BROOKS LANDING - PHASE II PUBLIC IMPROVEMENTS
CITIZEN ADVISORY COMMITTEE MEETING MINUTES - MEETING #5
APRIL 9, 2013 - 4:00 - 6:00 P.M.
GENESSEE WATERWAYS CENTER

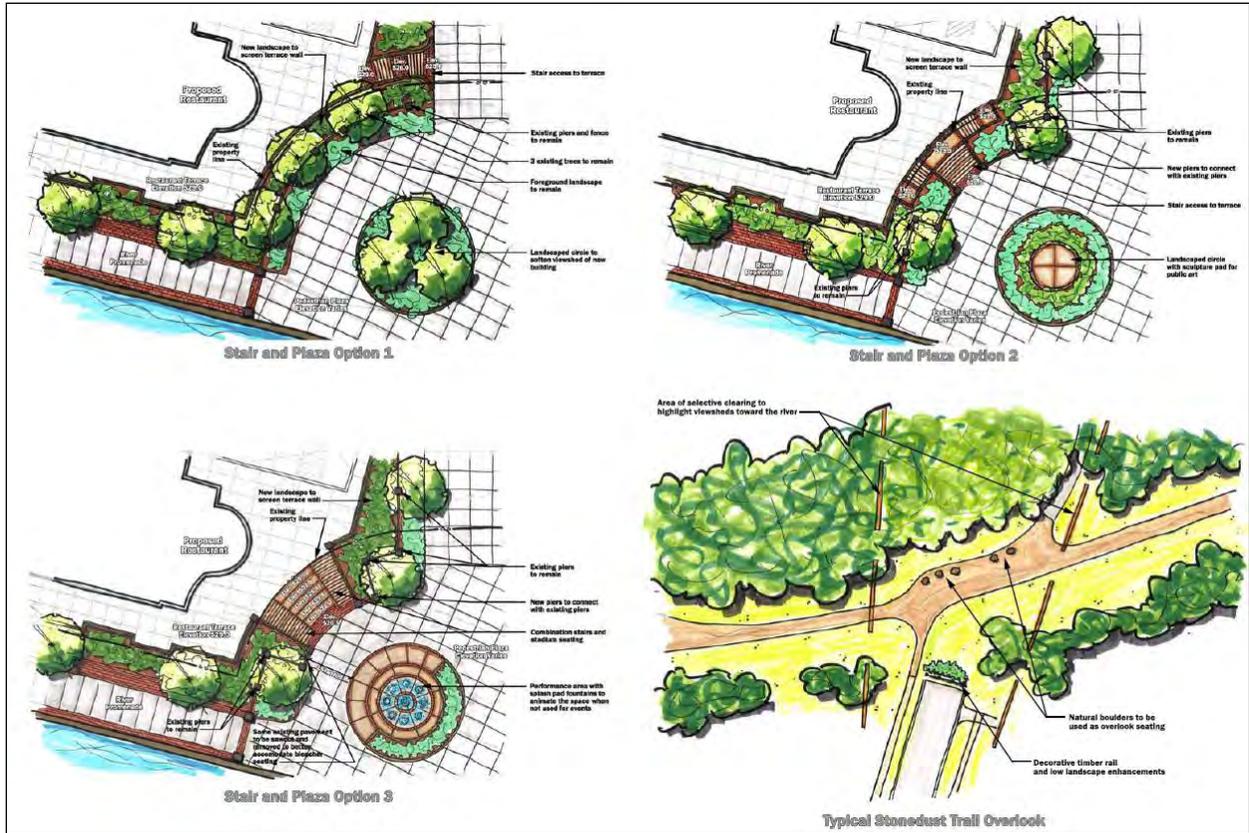
- The **ball field and baseball diamonds** are a critical component off the park but are not addressed as part of the project. There are significant drainage issues that need to be addressed for it to be usable for the full outdoor sports season. Why isn't it park of the project? Can it be?

- Can **power points** (electrical outlets) be provided throughout the park for general park users and organized events (movie nights, concerts, etc...)?
Power points are typically only provided at rental facilities (shelters, lodges, etc...) and will not be part of this project.

- What level of **lighting** will be provided along the trails, park road and turn-around, and connector drive?

We recognize that there are serious drainage issues associated with the open greenspace but will likely not be able to address it as part of this project. The

design team will spend some time looking at possible solutions and budgetary implications.

The City typically does not light our trails as they are considered part of the park system that is only open dawn to dusk. In special circumstances, typically in more developed areas such as Corn Hill Landing or the Brooks Promenade, will we provide lighting.

We intend to provide a minimal level of lighting along the park entry, parking and turn-around loop for safety purposes. As a parks facility it is open dawn to dusk and we do not want to encourage off-hour use.
